## **Residential Subdivision at Iron Gates**

**Peer Review of the Independent Assessment Report to the  
Northern Regional Planning Panel**

**PPS-2014NTH020 (DA 2015/0096)**

**July 2022**

Figure 19: Proposed Road 5 adjoining Lot 137 (Source: Drawing C132 Arcadis 18 July 2019)

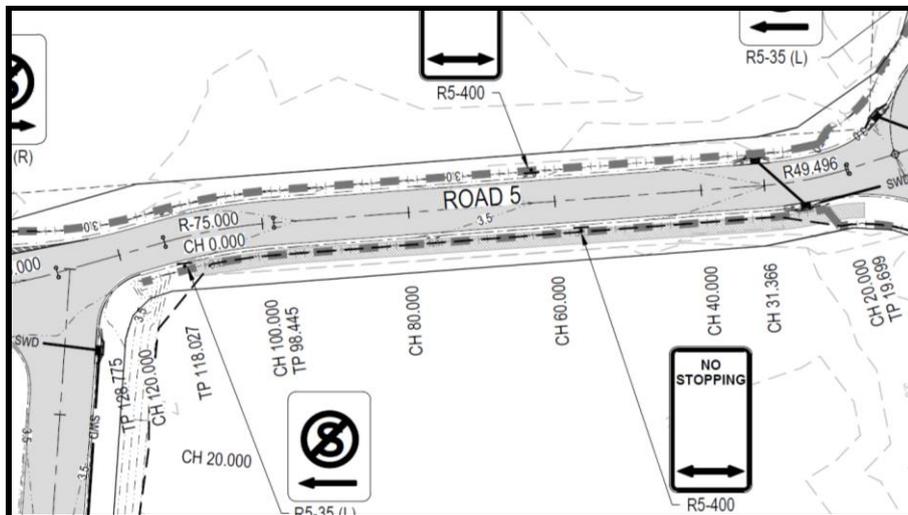
It is also considered that the proposed clearing of vegetation within this community on the site has been significantly under estimated by the 2019 Ecology Report, with **Figure 18** illustrating the current dirt track located on the site in the approximate location of proposed Road No 5 adjoining the rainforest lot. The Report states only 127m<sup>2</sup> of Littoral rainforest EEC (blue hatched area) for a sewer pump station and road extension between eastern and western residential areas is proposed.

Such clearing is also described by the 2019 Ecology Report as “*minor pruning of limbs on the edges of the Littoral rainforest*”. This clearing is likely to be greater than this and would involve more than just lopping of trees. Furthermore, it is also unknown whether any vegetation clearing is required to provide for the stormwater quality and quantity treatment basin which is also located within the C2 zone and within the proposed conservation area.

Figure 23: BCD Buffer Principles (Source: BCD Report, October 2020)

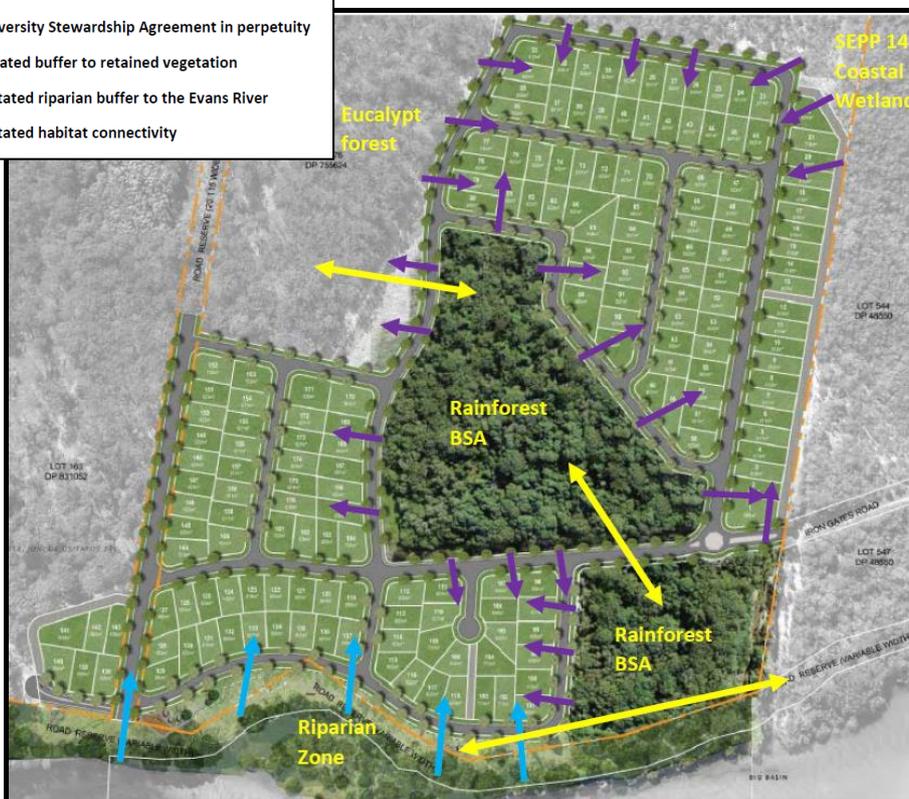
The retained rainforest lots are also separated from each other by proposed Road 5 as well as separated from the foreshore area by the proposed southwest portion of the subdivision and other roads proposed within the site. This results in a lack of vegetated habitat connectivity within the site and to the adjoining areas of native vegetation as outlined by the yellow arrows in **Figure 23**.

The BCD's recommended vegetated buffers have not been incorporated into the development design, which were intended to reduce the indirect impacts to the retained biodiversity on the site in both the rainforest and riparian areas (**Figure 22**). Instead of providing vegetated buffers to avoid indirect impacts, the applicant proposed the provision of 'offsets' for these impacts in the form of required biodiversity credits. Vegetated buffers surrounding the rainforest and riparian areas on the site, rather than offsets as required by the BC Act, would provide a more appropriate biodiversity outcome on the site and would also reduce the number of biodiversity credits the proponent needs to retire (if the BC Act were to apply).

**Figure 24: Impact and Revegetation Areas (Source: Attachment 2 - JWA Letter, 8 January 2018 of 2019 Ecology Report)**

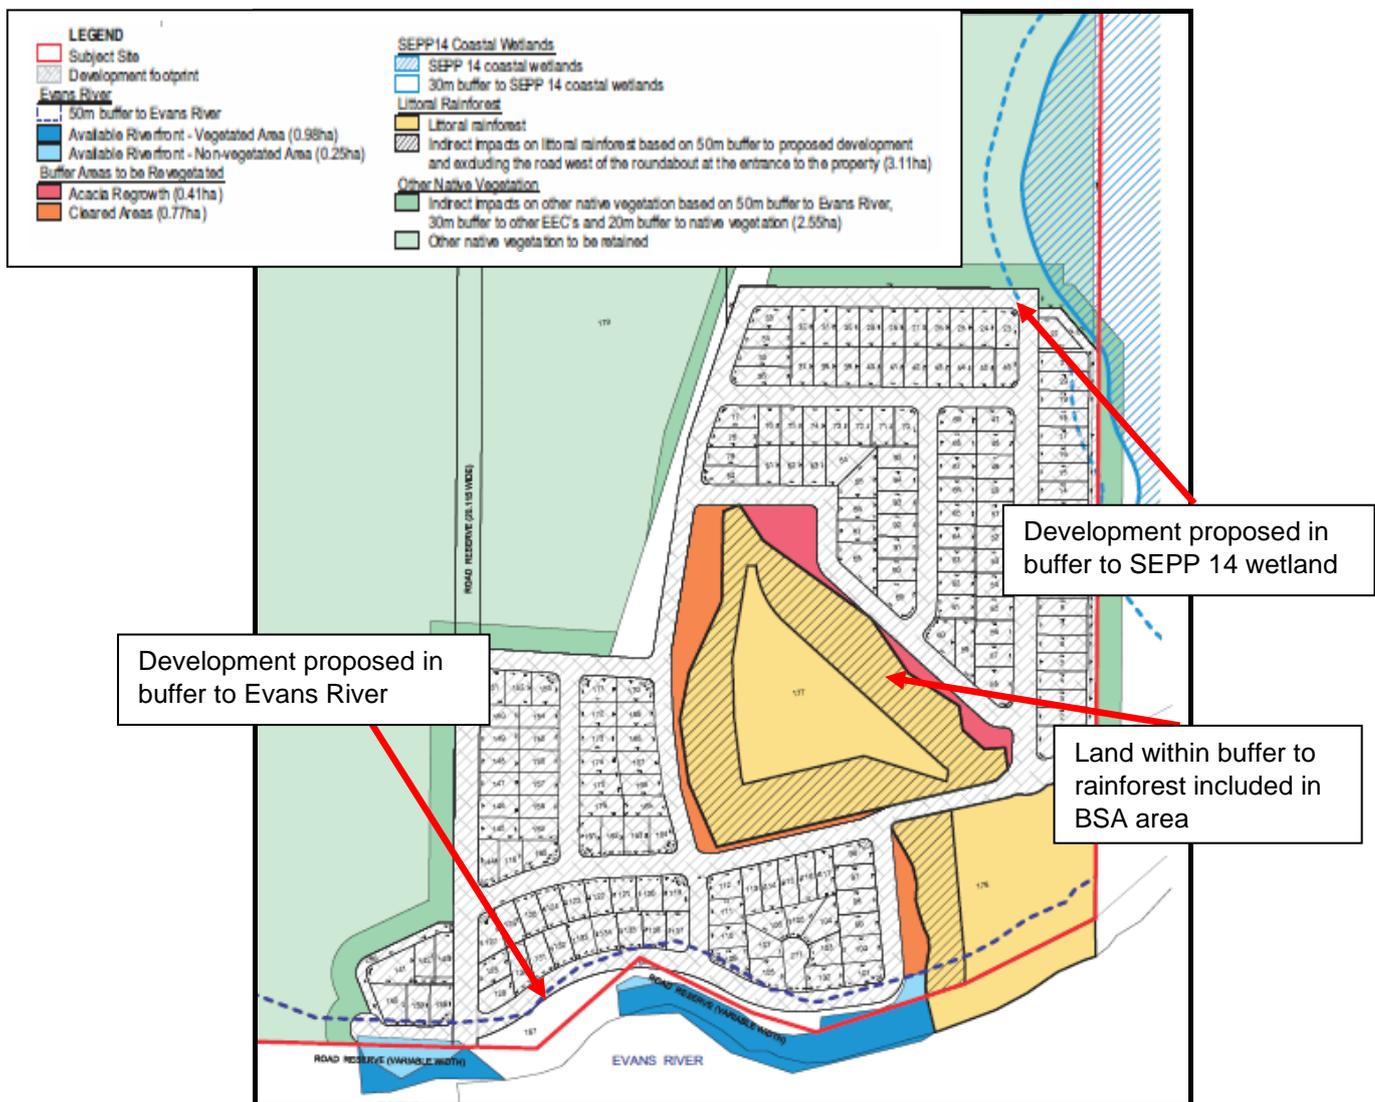
The applicant considered the provision of buffers during the negotiations around the provision of offsets and biodiversity credits in the 2019 Ecology Report (Attachment 6), illustrated in **Figure 24**.

Notwithstanding that an 'agreement' has been reached between the applicant and BCD for offsetting large areas of biodiversity impacts on the site, the BCD's preference has always been to avoid or minimise biodiversity impacts. The development proposes to remove areas of native vegetation. The retention of areas comprising native vegetation which avoids impacts, rather than offsetting those impacts by providing biodiversity credits, would more adequately address the ecological and biodiversity concerns of the proposal. Such vegetation retention is not simply reducing the overall removal of vegetation, but providing more appropriate protection for the remaining vegetation on the site through the provision of appropriate buffers and adequate mitigation measures to reduce edge effects.

Figure 27: Current proposed subdivision (Source: Landpartners 19 July 2021)

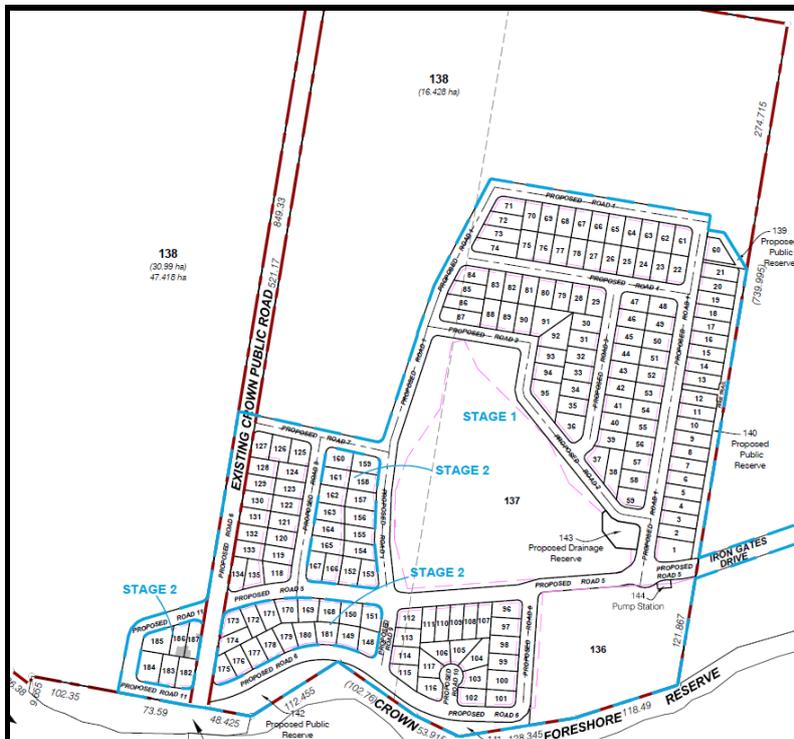
The proposed subdivision has been designed on the basis of the former subdivision approval (illustrated in **Figures 2** and **3** below). This design philosophy is flawed as the previous design also exhibited the same concerns as the current design in that there is a lack of site-specific planning, no perimeter road, a lack of lot diversity and a lack of legibility in the design.

**Figure 33: Proposed Pedestrian Network (Source: Landscape Statement of Intent, Plummer & Smith, 17 July 2019 Rev D)**

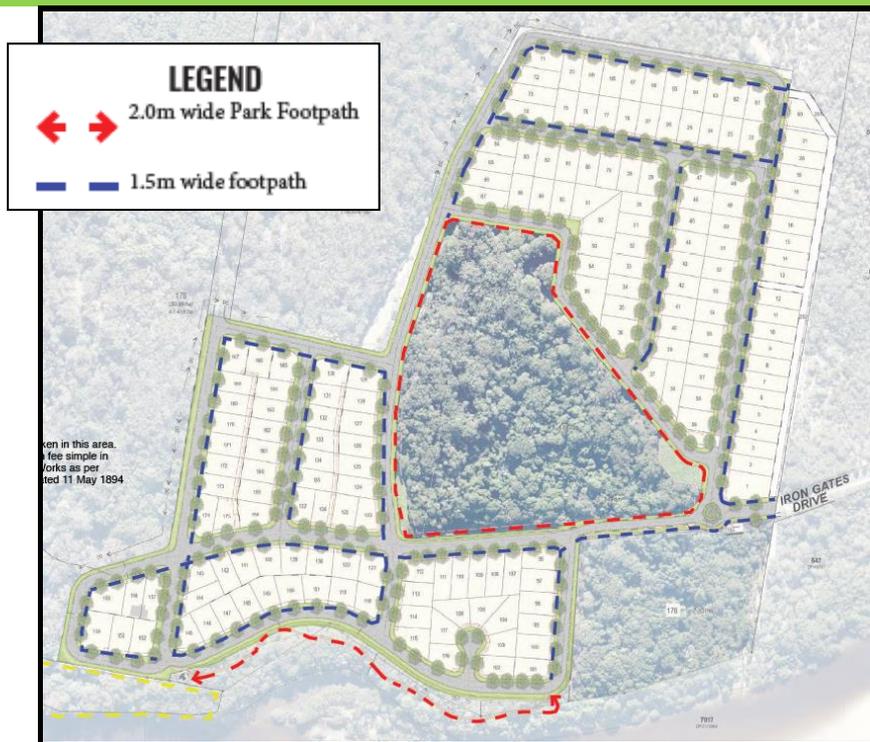
The proposal is also considered to lack of legible and connected pedestrian network within the design. The Landscape Statement of Intent provides a concept pedestrian layout (**Figure 33**), however, this does not account for site grades or vegetation which may need to be removed for such paths. It is also unknown whether these paths are located within the road reserve (with respect to overall widths) and whether the recommendation to provide a cleared space of 3 to 5 metres on either side of footpaths and cycle routes as recommended by the CPTED Report has been incorporated into the proposal and assessed for potential ecological impacts. The proposed pedestrian linkages throughout the site and to the surrounding area are poorly described by the proposal, which is unsatisfactory.

Accordingly, it is considered that the proposal has not provided adequate public open space for the future population of the site.

**Figure 36: Proposed Road 5 located between the proposed rainforest lots (Source: Arcadis)**

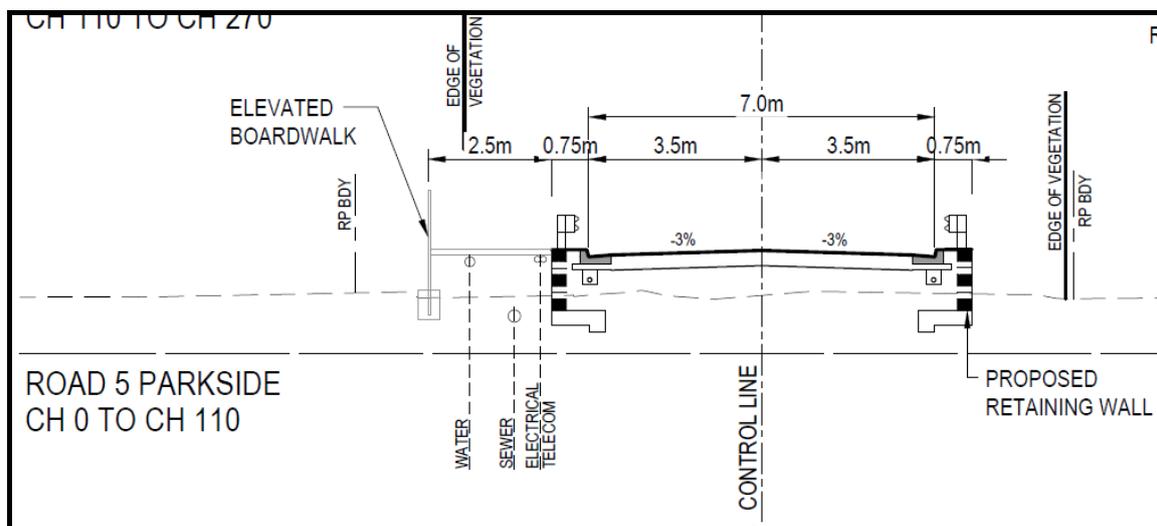
The engineering report states the following in relation to this section of proposed Road 5 and illustrated in **Figure 36**:

*A section of the Proposed Road 5 between chainage 20 and 140 has been designed with a reduced verge and pavement width to minimise impacts on the environmentally protected areas to the north and south of the road. The adopted cross-section shown on Drawing C140-AA007094-07 in Appendix A, shows two 3.5m lanes without the additional 2m parking zones on each side of the road. Safety barriers (guard rails) have been adopted on both sides of the road to help in minimizing the total width. No verge is proposed on the northern edge of the road. Along the southern edge a 2.5m wide elevated platform will be provided as a pedestrian connection between the wider sections of the road.*

**Figure 40: Proposed Sedimentation Pond in SEPP 14 wetland (Source: Arcadis July 2019)**

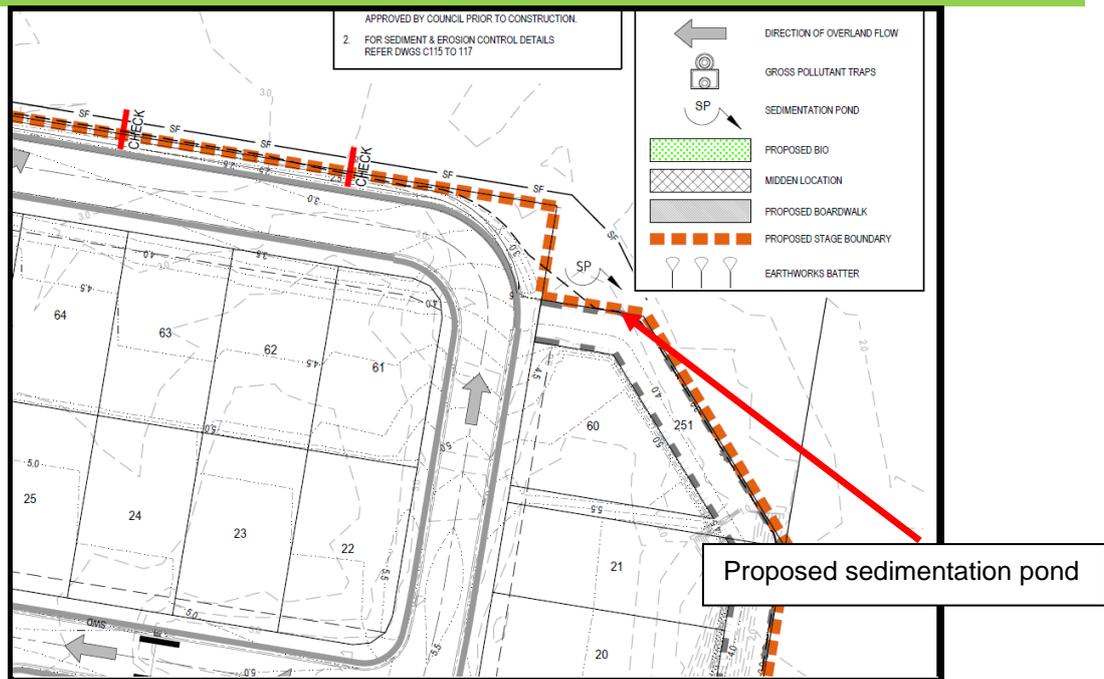
2. Sedimentation Pond – It appears from the servicing plan that a sedimentation pond is proposed within the SEPP 14 wetland and its associated buffer in the north-east corner of the site (**Figure 40**). There are no details or diagrams outlining this stormwater infrastructure however it is considered to be unacceptable in this location.
3. Lack of a Stormwater Management plan – The proposal does not include a stormwater management plan which outlines the proposed stormwater arrangements for the site and which demonstrates that the quality of the stormwater leaving the site is sufficient that there will not be an adverse impact on the environment.

The proposed arrangements for stormwater management on the site have not been clearly outlined by the proposal and are unsatisfactory.

**Figure 41: Proposed Earthworks (Source: adapted from Arcadis, 18 July 2019)**

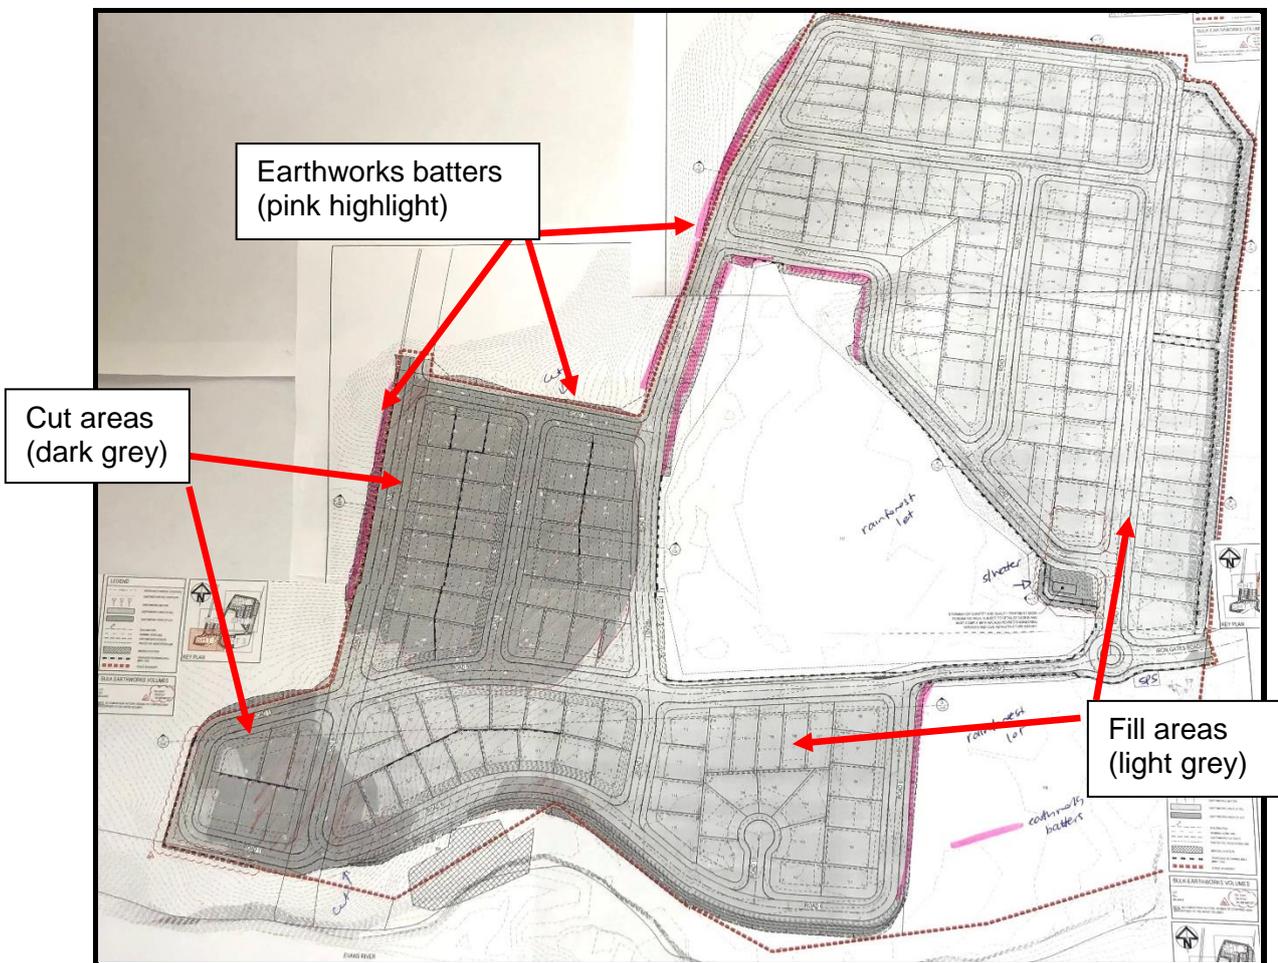
All of the proposed lots have some degree of earthworks where there is significant changes to the natural topography on the site through site regrading works. It is assumed that this is to provide terraced building lots, suitable for project home development. The proposed areas of cut (dark grey) and fill (light grey) are illustrated in **Figure 41**, which is adapted from the engineering plans.

Figure 44: Buffers as outlined in the 2019 Ecology Report

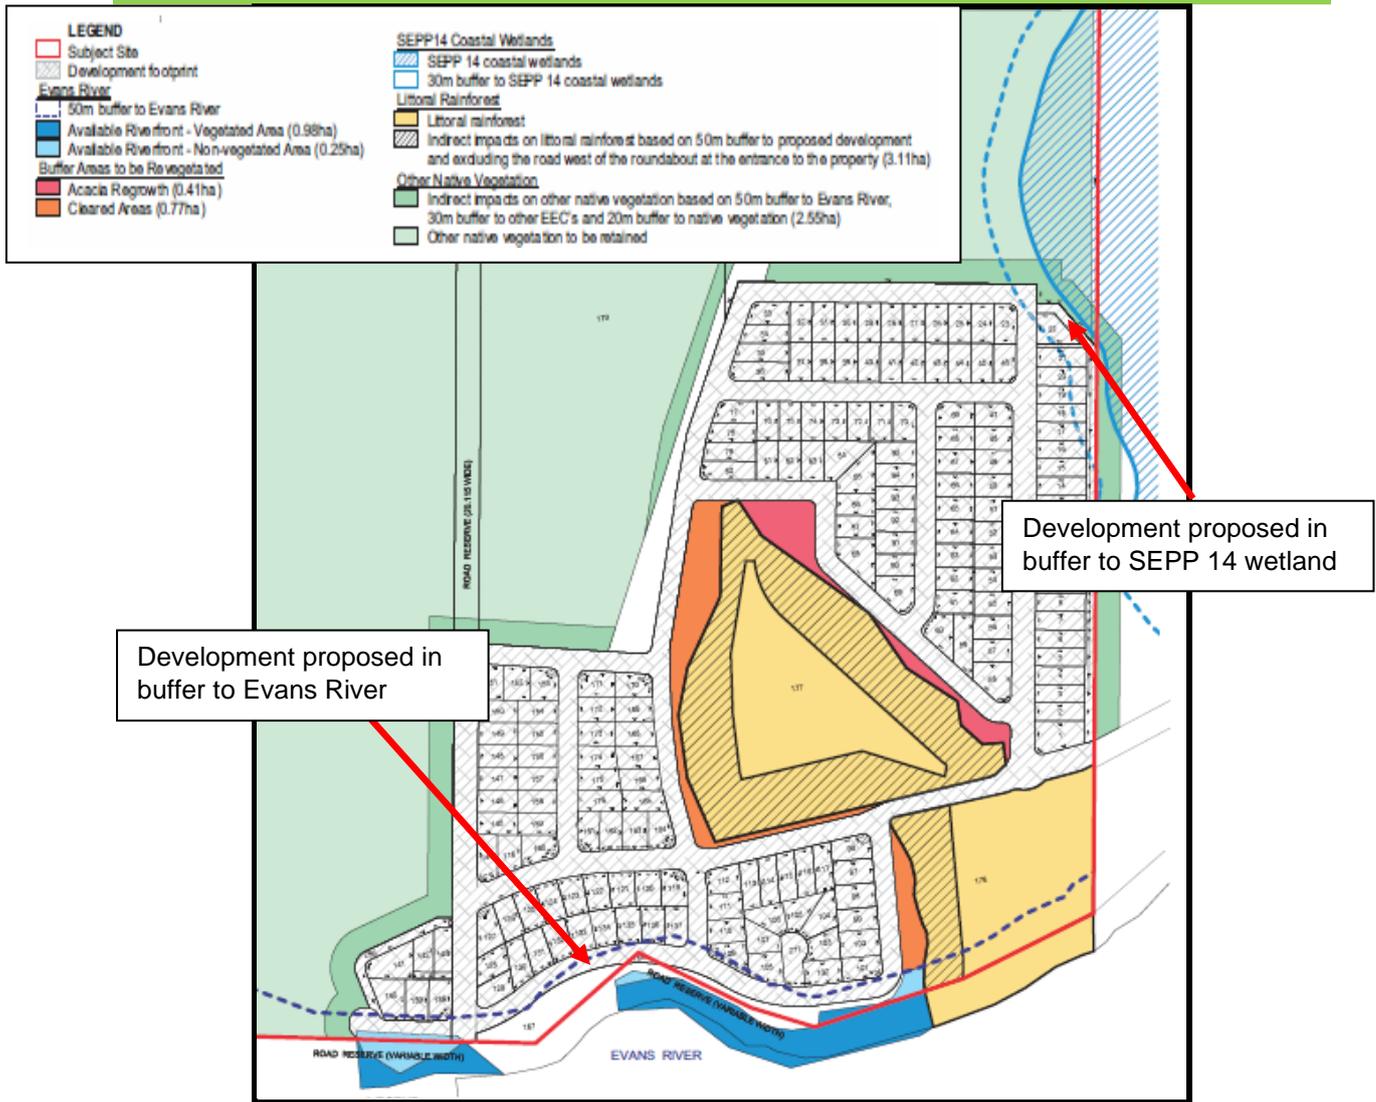
As outlined in **Figure 44**, there is also no buffer to this SEPP 14 wetland with proposed residential lots (Proposed Lot 60) and roads and fire trails proposed in the 30 metre buffer proposed by BCD to this SEPP 14 wetland boundary.

Accordingly, the potential impacts to the SEPP 14 wetland have not been adequately considered by the proposal and is therefore inconsistent with Clause 2 of SEPP 14.
